BUILDING CODE OF AUSTRALIA COMPLIANCE ASSESSMENT REPORT

CHILD DEVELOPMENT INSTITUTE – RESPITE AND EARLY INTERVENTION THERAPY

173 WARRINGAH ROAD, BEACON HILL

REPORT NO. ► PROJECT 10666 - REV 3.0

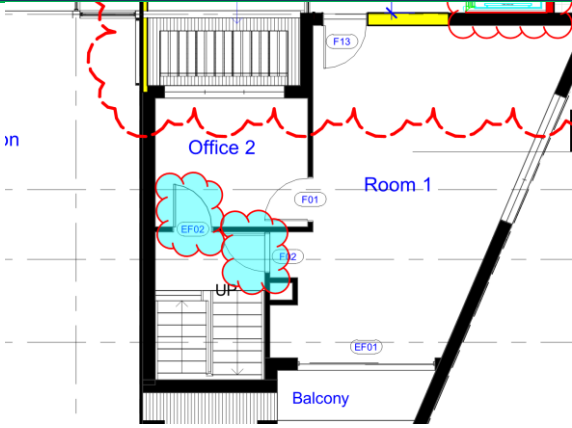
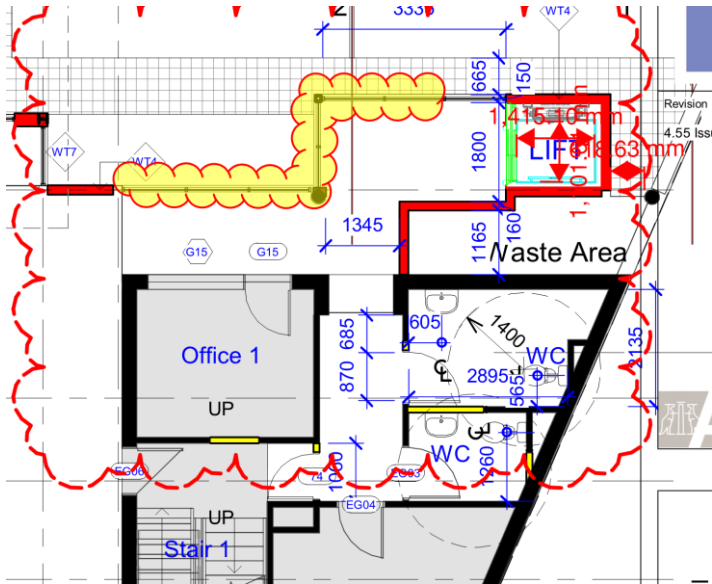
BCA Clause	Deemed-to-Satisfy Provision to be addressed
	7. Floors: see clause C2.9. 8. The columns and beams supporting the floor shown in the photos below do not appear to provide an FRL 120/-/. Structural engineer to confirm the FRL of the column and beams or otherwise, columns to be upgraded to comply. Details on how the columns will comply is to be provided.   9. Structural engineer to inspect the floors to determine whether the floor provide an FRL no less than 120/120/120. The structural engineer is to confirm the FRL of the existing floors and CC drawings to detail the lightweight floor system which is to sit above or below the existing slab where the slab does not achieve an FRL 120/120/120.

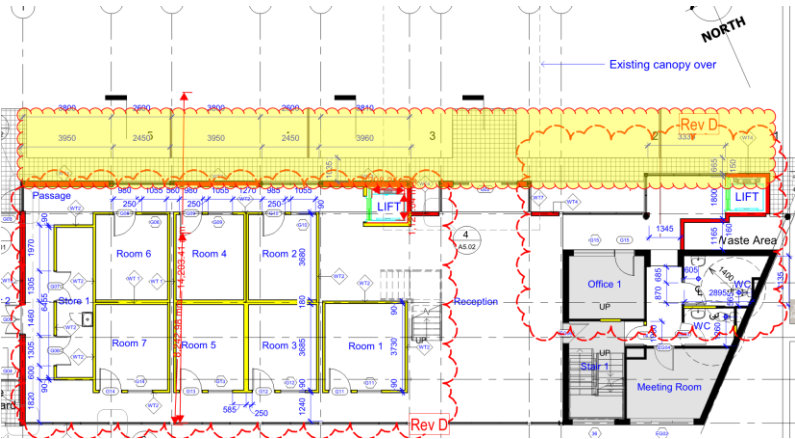
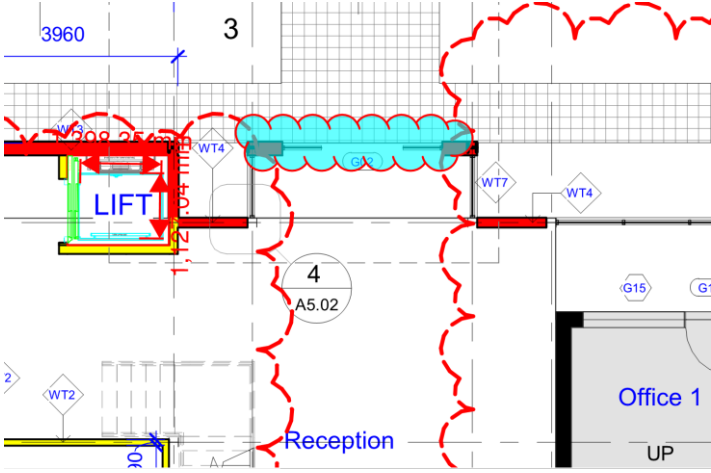
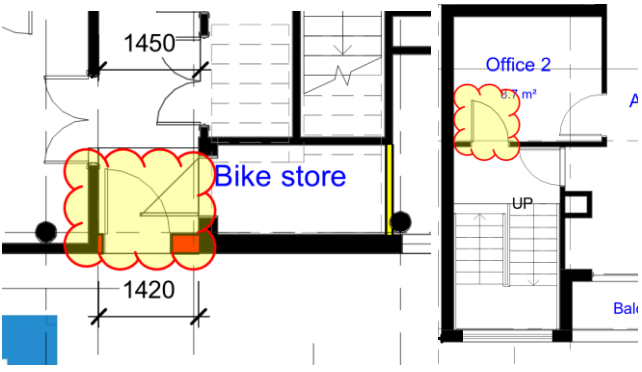
C2.9 Separation of Classifications in different storeys	Structural engineer to inspect the floors to determine whether the floor provide an FRL no less than 120/120/120. The structural engineer is to confirm the FRL of the existing floors and CC drawings to detail the lightweight floor system which is to sit above or below the existing slab where the slab does not achieve an FRL 120/120/120.
C3.2 Protection of openings in external walls	The openings within the external walls and located within 3m of the western boundary is to be protected in accordance with Clause C3.4 or addressed by way of a Performance Solution by a fire engineer at CC stage. Examples are highlighted below in blue.

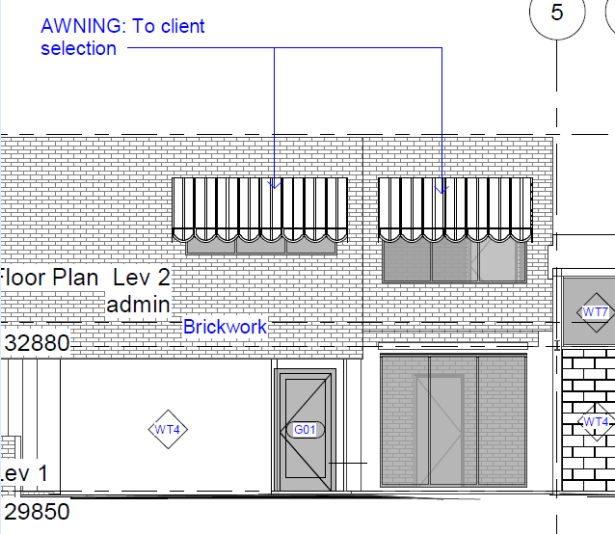
C1.9 Non - combustible building elements		X			The building is noted as being covered in part with cladding (see photo below – refer to grey panels). The structural CC involves the removal of the existing cladding and replacement of the existing cladding. The CC drawings are to detail the

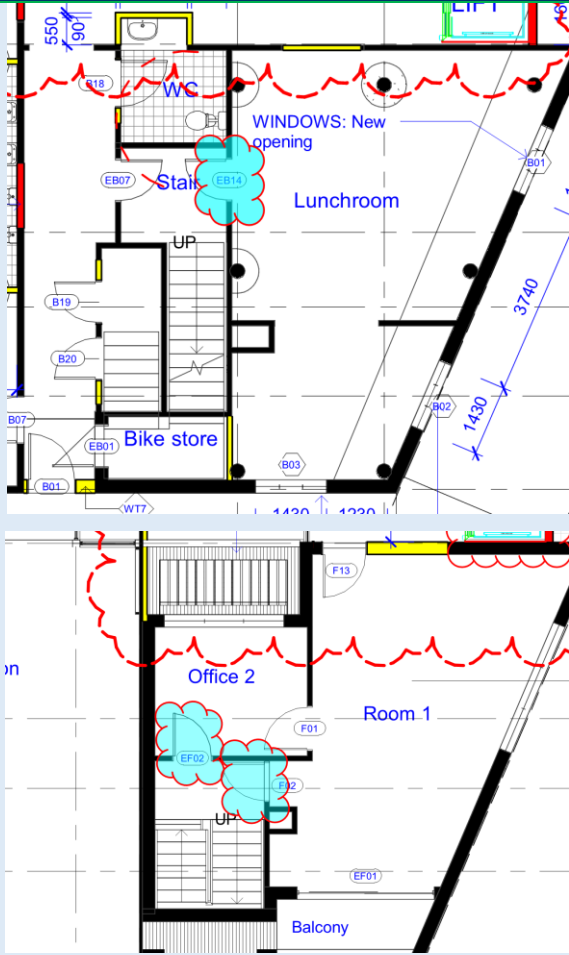
D1.4 Exit Travel Distances	X				Complies.
D1.5 Distance Between Alternative Exits	X				Complies.
D1.6 Dimensions of Exits and paths of Travel to Exits		X			<u>Compliance issue:</u> The passageway behind the WC on level 0 is less than 1m (960mm noted).

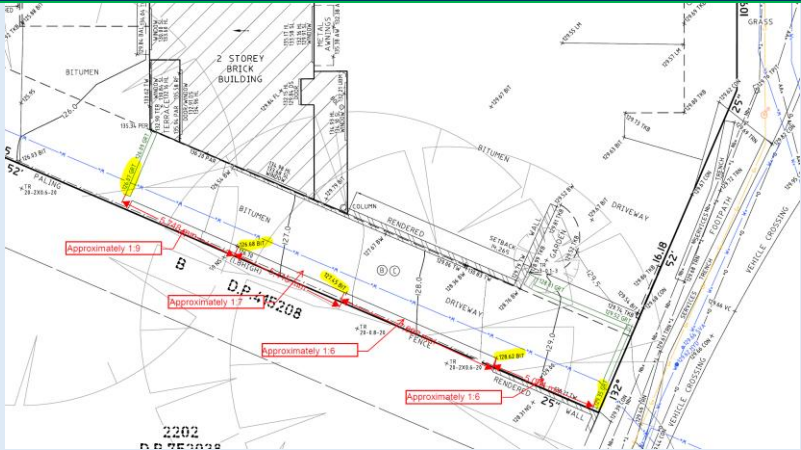
D1.7 Travel via Fire Isolated Stairs		X			<u>Compliance issue:</u> ▪ The following areas provide doorways that swing directly into the fire-isolated stairways contrary to Clause D1.7(a): ○ Level 0 – The lunchroom; ○ Level 2 – Room 1 and office 2.

BCA DEEMED-TO-SATISFY PROVISION	COMPLIES	DOES NOT COMPLY	NA or Informational	Compliance Required	COMMENTS
					 The FER is to be updated to reflect the amendments listed above. ▪ The fire-isolated stairway does not discharge by way of a fire-isolated passageway to a road or open space as required by D1.7(b). This has been addressed by way of a Performance solution by the fire engineer. ▪ An egress doorway is to be detailed on level 1 from the lift lobby to determine the openings needed to be protected internally as per C3.4 of the BCA as per Clause D1.7 (c)

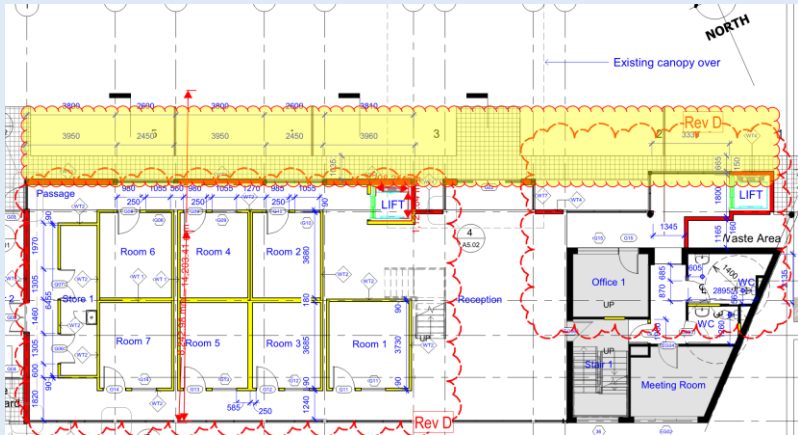
D2.4 Separation of Rising and Descending Stairs	X				The rising and descending nature of the stair 1 has been addressed by way of a Performance solution by the fire engineer. Design requirements If a stairway serving as a required exit is required to be fire isolated – (a) There must be no direct connection between – (i) A flight rising from a storey below the lowest level of access to a road or open space; and (ii) A flight descending from a storey above that level ; and
